G0.10 --- CODE ANALYSISREVISED SUBMITTAL - PL20220623

G0.10 --- CODE ANALYSISORIGINAL SUBMITTAL - PL20220623

The Amble

The Amble Steamboat, CO

A1.06 --- ROOF PLAN
REVISED SUBMITTAL - PL20220623

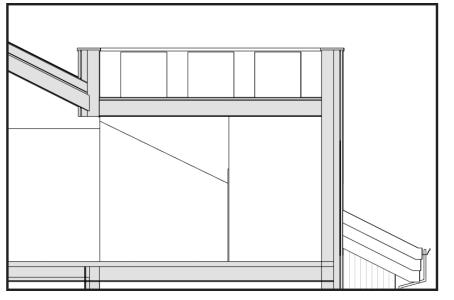
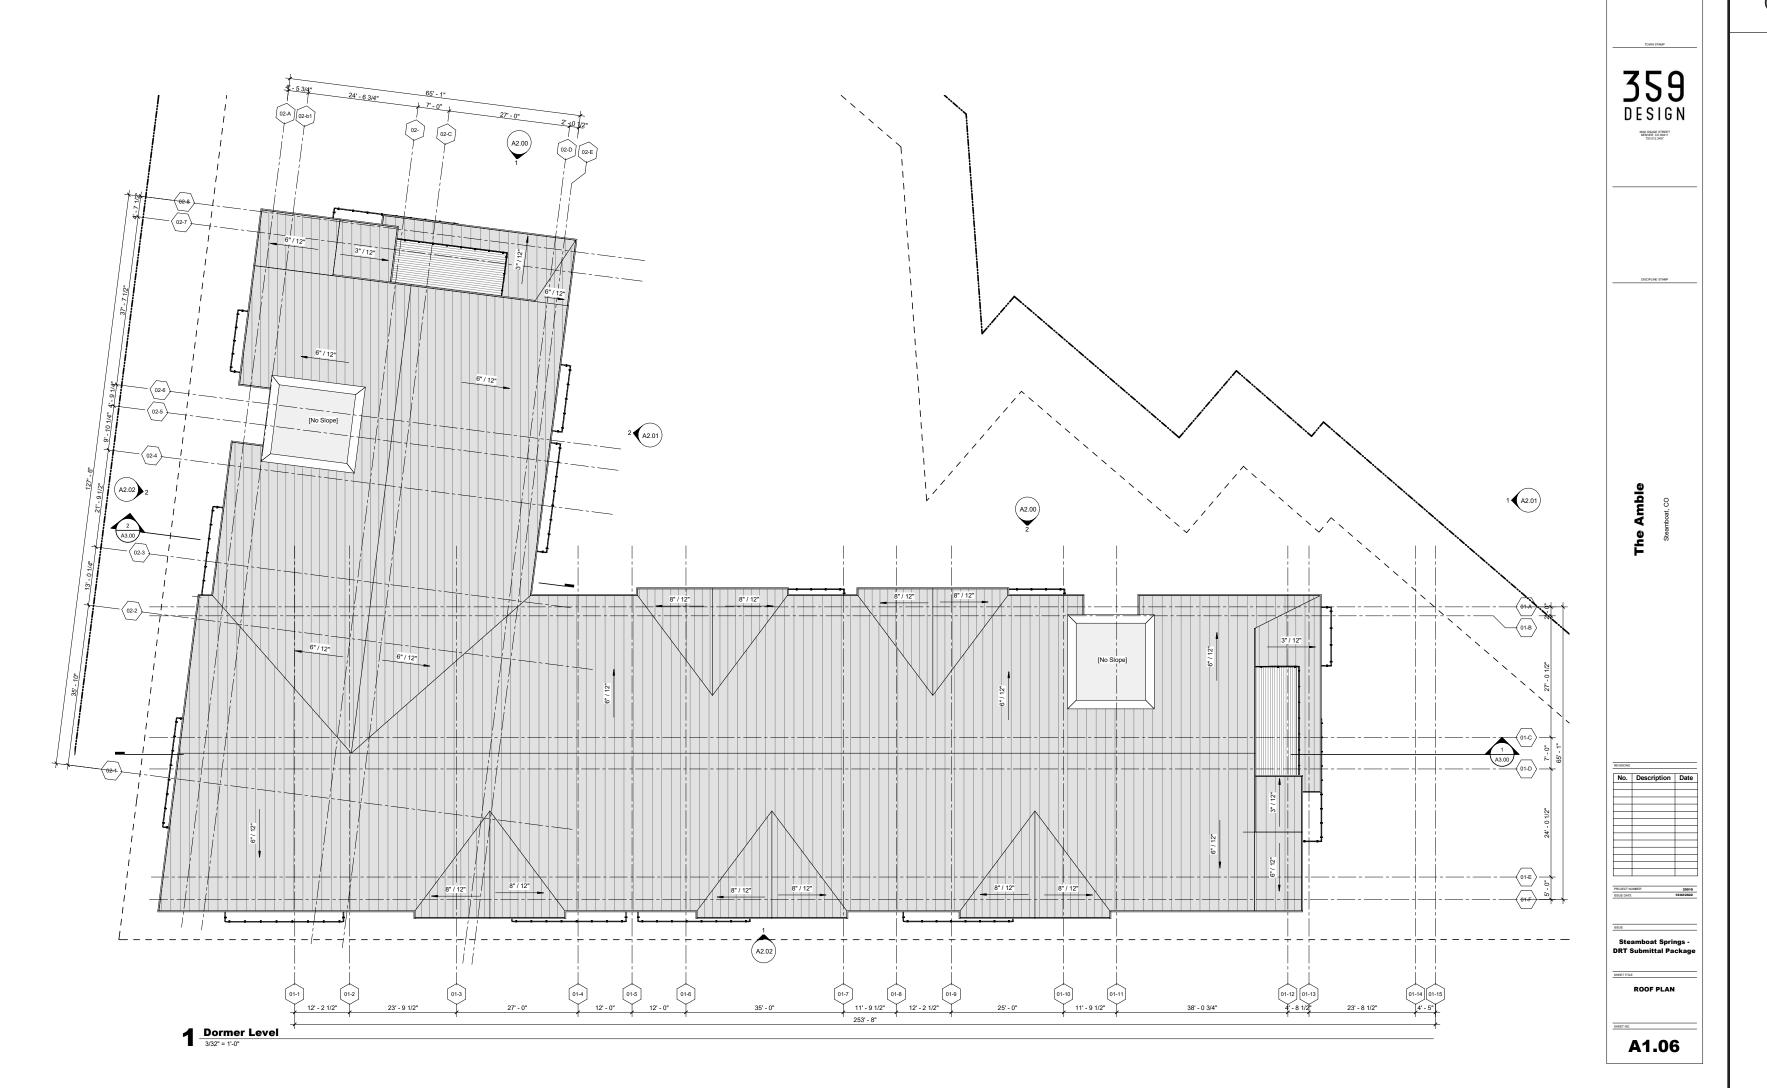
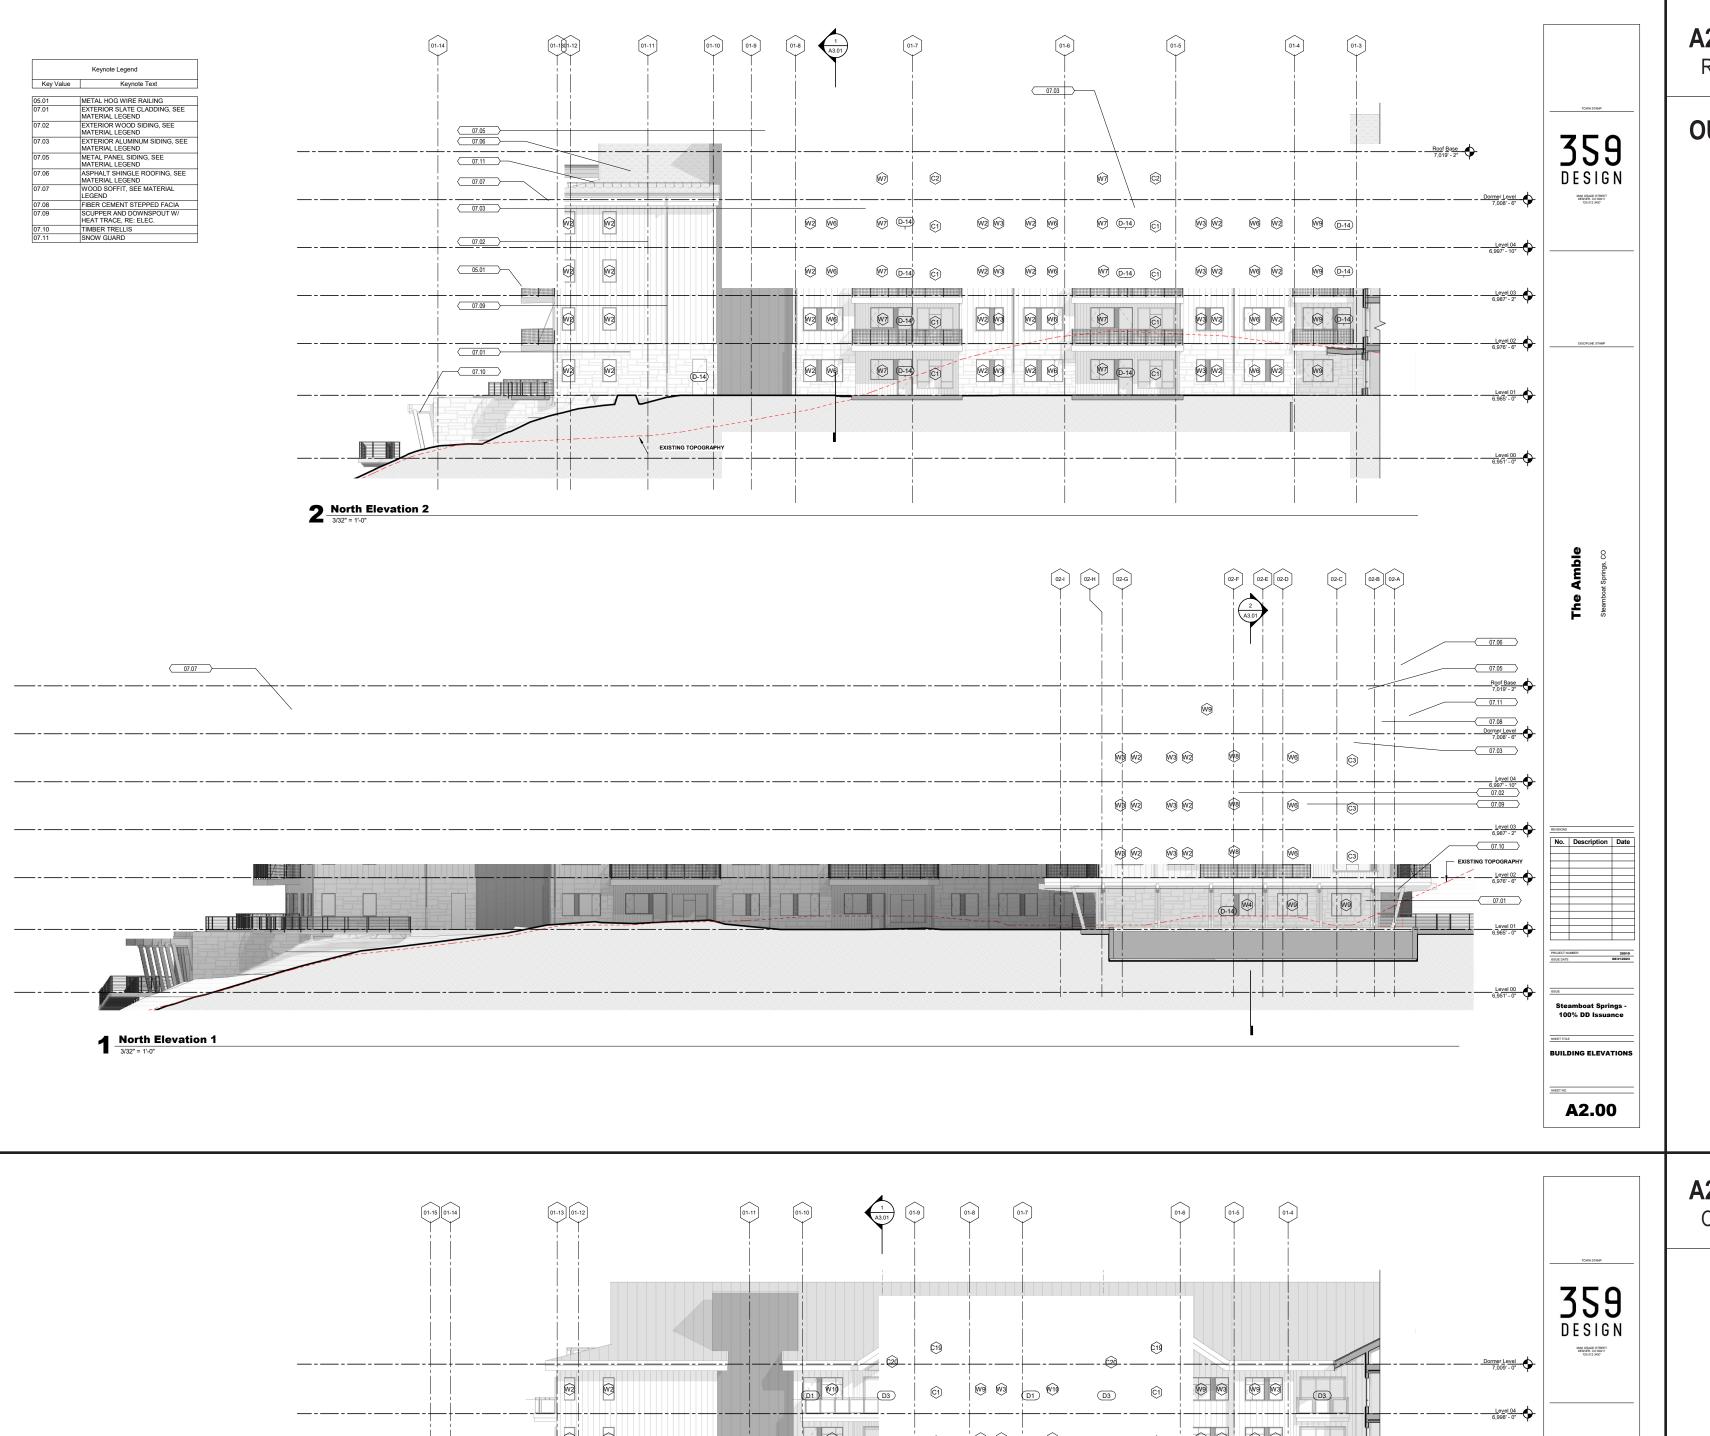
- 01. PREVIOUS 8:12 GABLE ROOFS UPDATED TO 3:12 SHED ROOFS.
- 02. 60% OF THE TOTAL ROOF AREA IS STILL 6:12 GABLE ROOF WITH THE UPDATED DESIGN.
- 03. AS HIGHLIGHTED BELOW IN PLAN AND SECTION (NOTE: THE SECTION IS NOT PART OF THE SET, BUT IS ADDED FOR REVIEW CLARITY HERE), THE DESIGN HAS ADDED FOUR UPBLAST FANS ON TOP OF THE WEST CORE. THE WALLS OF THE CORE CONTINUE VERTICALLY TO SCREEN THESE UPBLAST FANS, PROVIDING A DESIGN THAT SCREENS THE FANS WHILE INCORPORATING THE STANDARD ARCHITECTURAL FACADE PER THE REQUIREMENTS OUTLINED IN SDC SECTION 440.K.

A7.01 --- GLAZING REVIEW

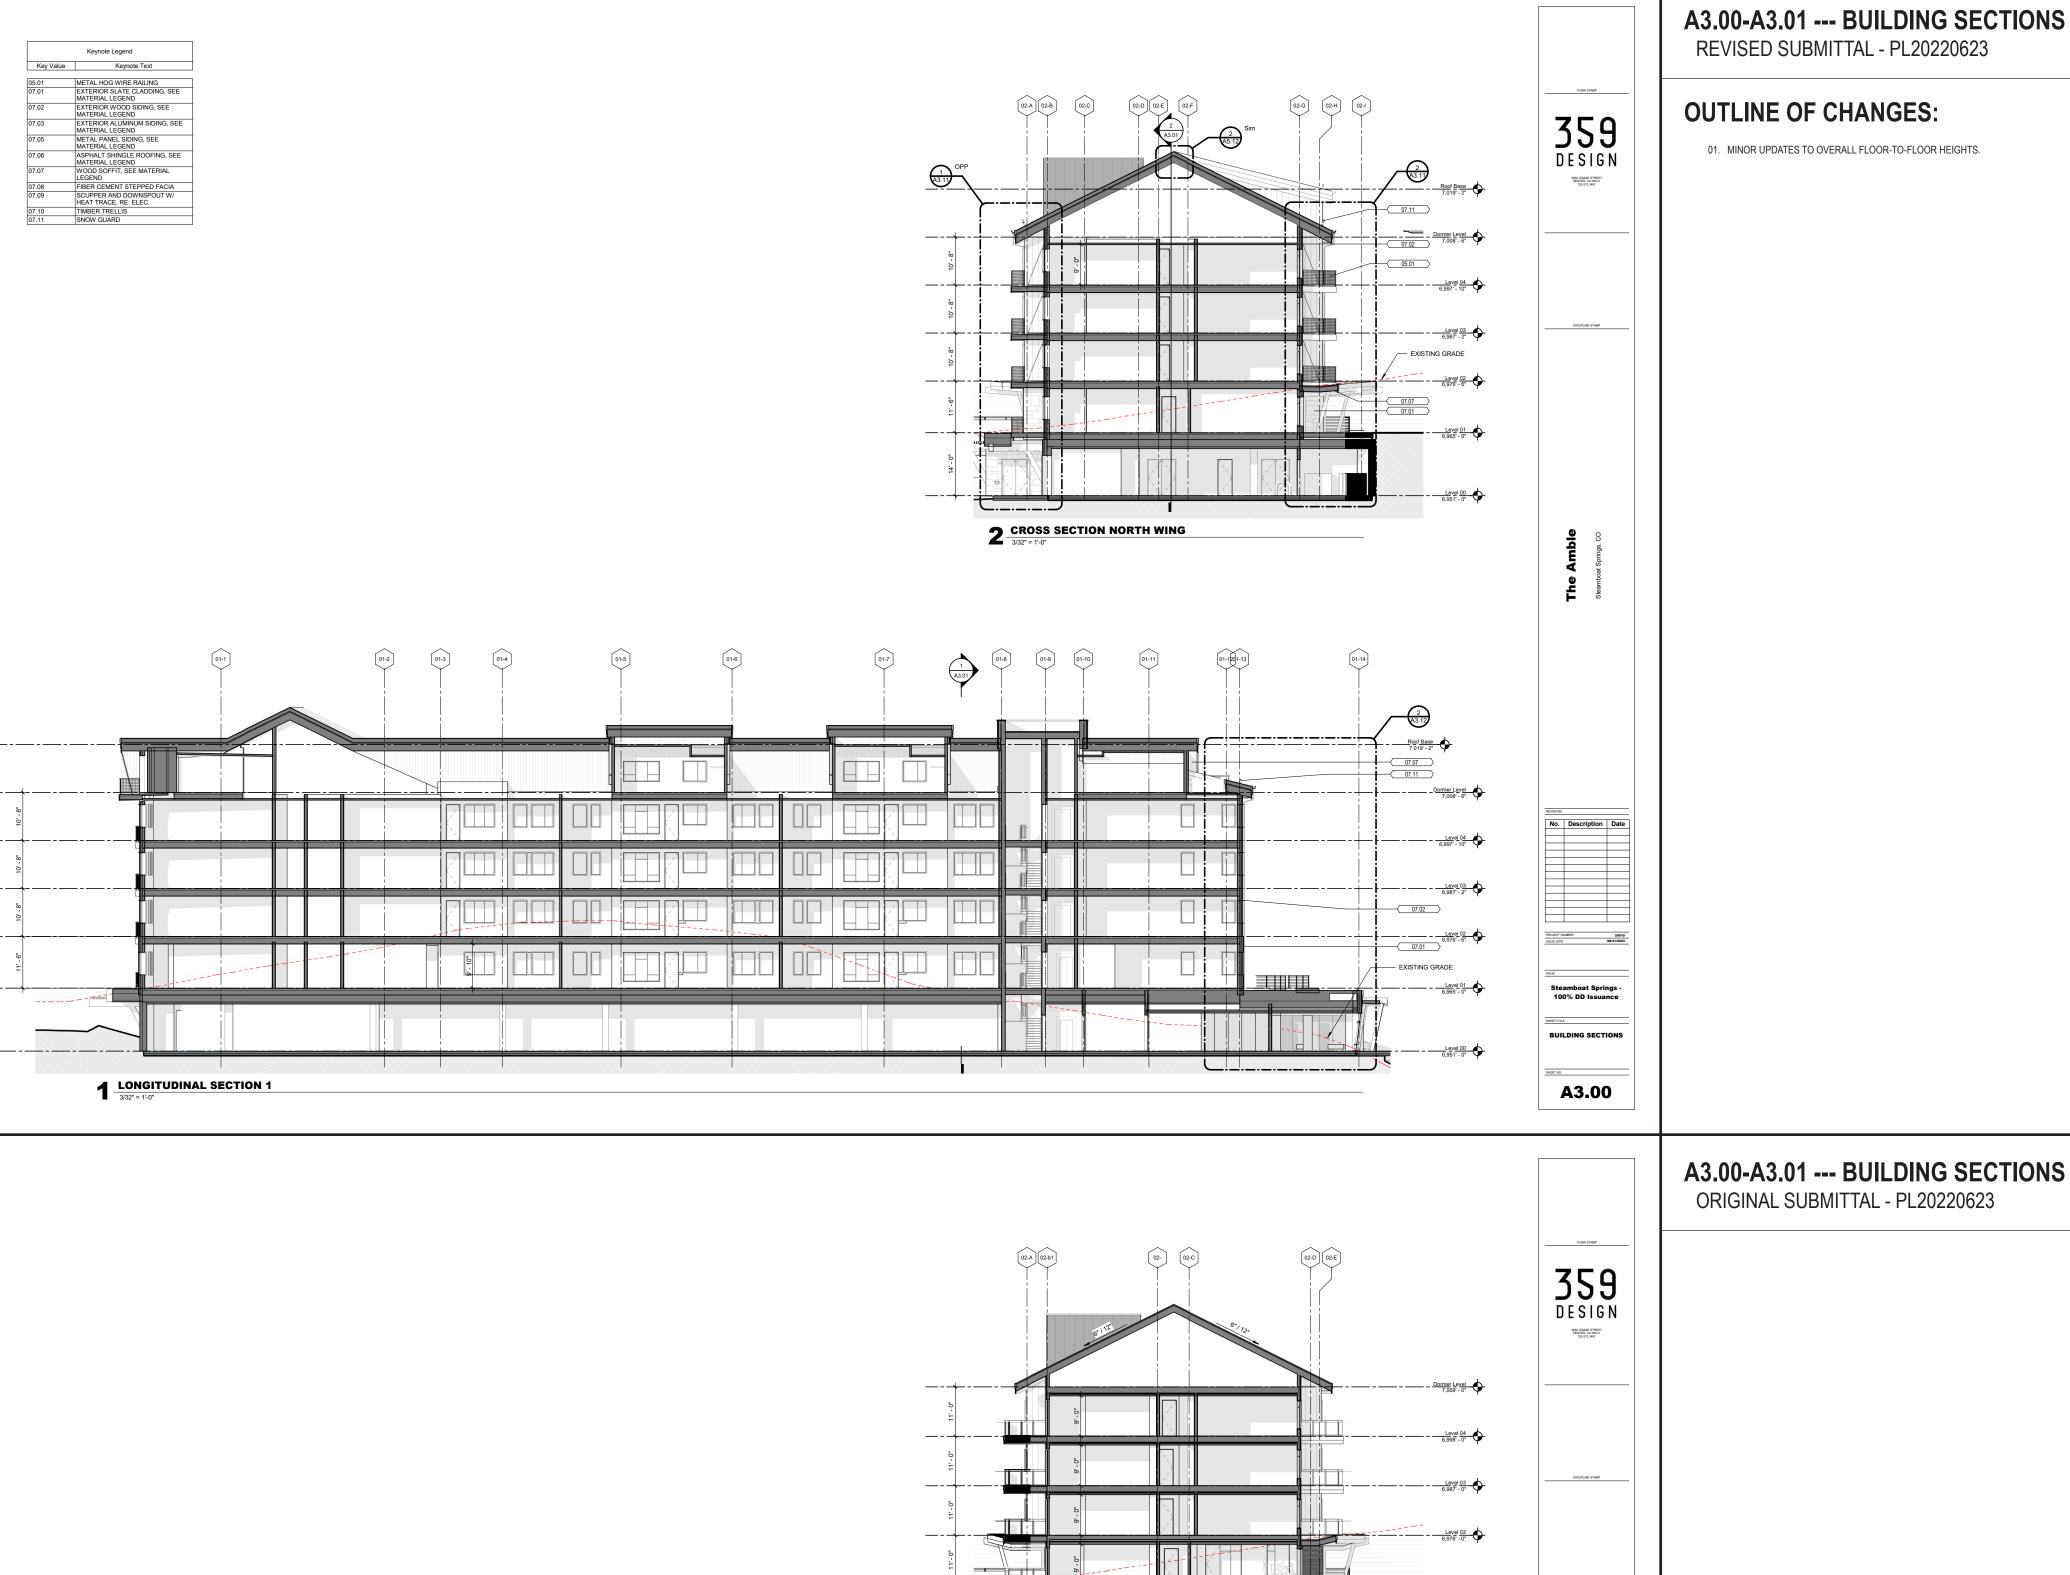
01. SHEET NUMBER CHANGED FROM A2.20 TO A7.01.

02. GLAZING PERCENTAGE UPDATED FROM 29.6% TO 25.15%.
